REQUEST FOR CITY PLAN COMMISSION REVIEW

Date:	August 1, 2016
Applicant:	Bob Clark, CEO of Clayco Construction
Owner:	Hanley-Forsyth, LLC; Clayton Property Investment, LLC; Forhan, LLC; Centene Center II, LLC; CMC Real Estate Company, LLC; Health Plan Real Estate Holding, Inc.
Project Address:	7454, 7510, 7518, 7520, 7528, 7600, 7606, 7630, 7632, 7636, and 7642 Forsyth Boulevard; 12, 14, 20 and portion of 106 South Hanley Road; 10 South Lyle Avenue; 101 and 105 Carondelet Plaza; 7711 and 7733 Carondelet Avenue and adjacent proposed vacated rights-of-way.
Item Type:	Rezoning & Special Development Plan
Staff:	 Louis Clayton, AICP, Planner
Summary:	Review of a request to rezone subject properties from the existing base and overlay zoning districts to Special Development District (SDD).

Date:	August 1, 2016
Applicant:	Bob Clark, CEO of Clayco Construction
Owner:	Hanley Forsyth, LLC
Project Address:	7630-7642 Forsyth Boulevard; 12, 14, 20, and part of 106 South Hanley; vacated Carondelet Avenue and alley
Item Type:	Special Development Subdistrict & Site Plan Review
Staff:	 Louis Clayton, AICP, Planner
Summary:	Review of the Special Development Subdistrict Plan and Site Plan associated

Proposed Rezoning: Subject properties outlined in red.

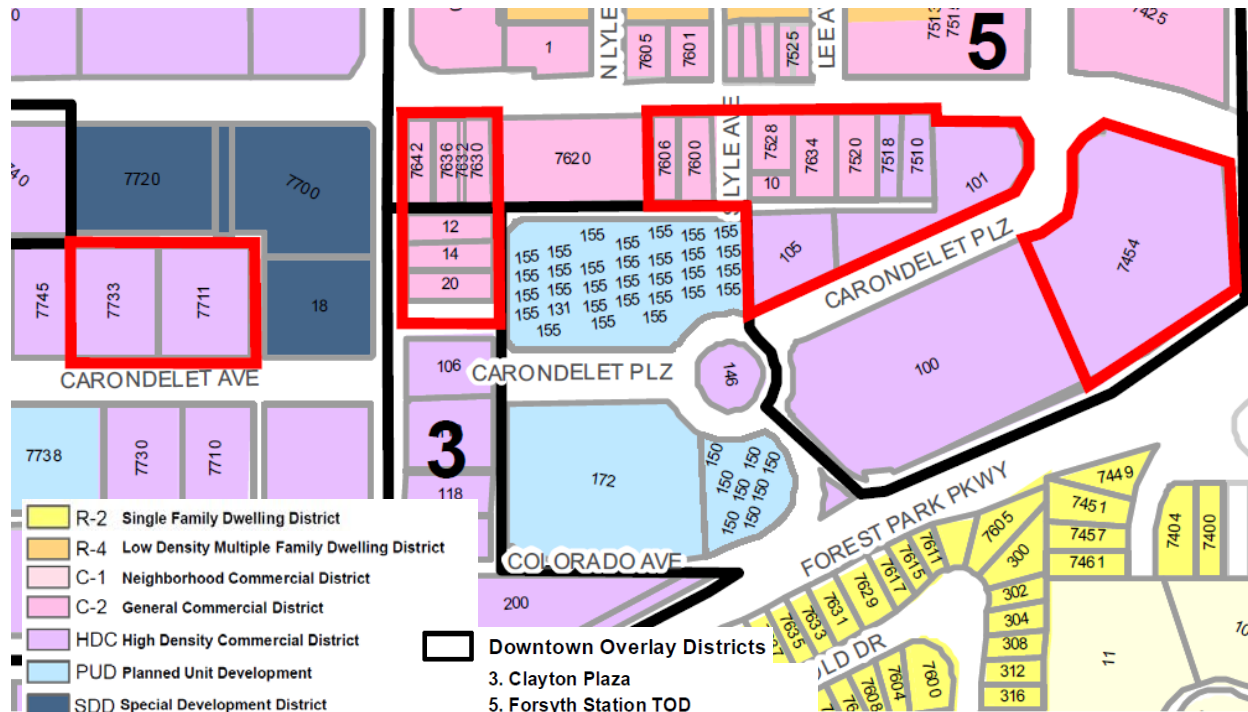
The applicant requests to rezone all property located within the proposed Subdistricts, with the exception of 18 South Hanley and 7440 Forsyth Boulevard, from the existing base and overlay zoning districts to Special Development District (SDD). The properties to be rezoned are outlined in red in the following zoning map. 7632 Forsyth Boulevard (located between 7630 and 7636 Forsyth

Boulevard) is not included in this request due to a publication error. It will be considered at an upcoming meeting once it has been properly advertised.
